**ANALYSIS AND FINDINGS**  
**for Tualatin Logistics Park**  
 March 9, 2022

| Case #:    | AR 21-0011                                  |
| Project:   | Tualatin Logistics Park                     |

Figure 2: Site Plan (overview)

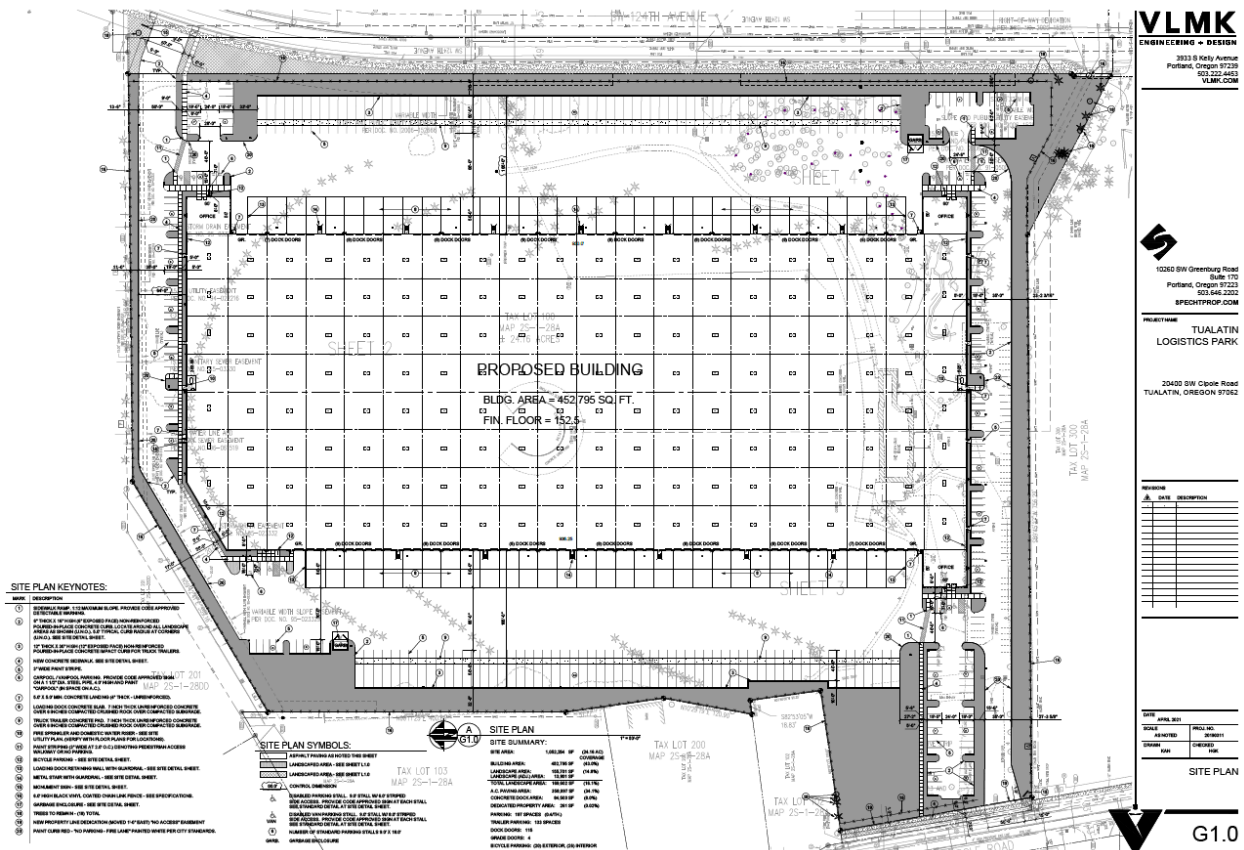
*Proposed driveway widths are illustrated at 50 feet and exceed the maximum width, as shown on the Site Plan in Exhibit A2. Access findings are further addressed in Chapter 75. With recommended Condition of Approval A11.d., these standards are met.*

*Given that a minimum of 136 parking spaces are required based on the proposed use, 3,400 square feet of parking lot landscape island area is required. It's unclear on the Site Plan or Landscape Plan (Exhibit A2) if the required parking lot landscaping area is met. Given 136 parking spaces, 34 trees are required and 57 are proposed. Curbs are included in the design and islands are provided at aisle ends. The*

*There are two driveway approaches proposed for this project, as shown on the Site Plan included as Exhibit A2. The applicant is proposing a new driveway on the northeast portion of the site with access from SW 124<sup>th</sup> Avenue. Access for this driveway is limited to right-in, right-out movements to minimize impacts to the Major Arterial. The applicant will construct a raised median at the proposed driveway location to limit the turning movements. The applicant has proposed a 50-foot wide driveway, which does not meet the City’s design standards. The applicant shall submit turning templates to show the wider driveway provides safe turning movements.*
